**Documentation on adjustments to the Draft Version of the Public Tool to produce the Final  
Version of the Public Tool  
(Proceeding R.14-07-002)**

This document provides information for stakeholders on questions posed on functionality of the draft version of the Public Tool, calculation errors identified in the draft version of the Public Tool, and subsequent changes made by E3 to the Public Tool in order to produce the final version of the Public Tool. **Items highlighted in yellow are new additions from the previously posted version of the document.**

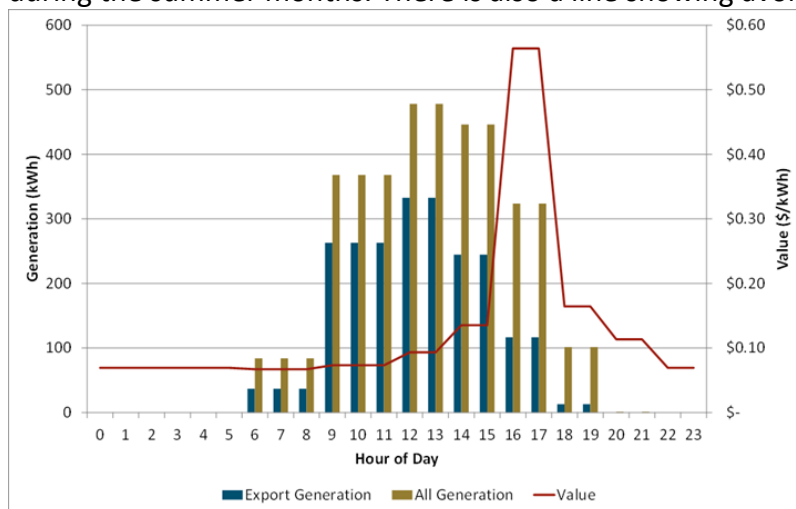
**116. Why do residential MW adoption and percentage cost of service recovery decrease when a \$24/kW-yr nameplate grid charge is added to the DER Low Bookend 2-tiered case (published date 06172015)? These results are counterintuitive.**

These counterintuitive results are driven by system sizing incentives. Adding the \$24 grid charge reduces the number of DER systems adopted, but it simultaneously encourages participants to install larger DER systems. The grid charge essentially reduces the negative impact of the minimum bill because it brings total charges above or closer to the minimum bill. In the case described here with a \$24 grid charge, 74% of all systems are large. In the case without a grid charge, only 48% of all systems are large. The larger system sizes cause the total MW adoption

to be higher in the case with the \$24 grid charge. Larger system sizes also reduce the numerator of percentage cost of service recovery.

Note that the addition of a grid charge only has this impact on sizing for classes with minimum bills.
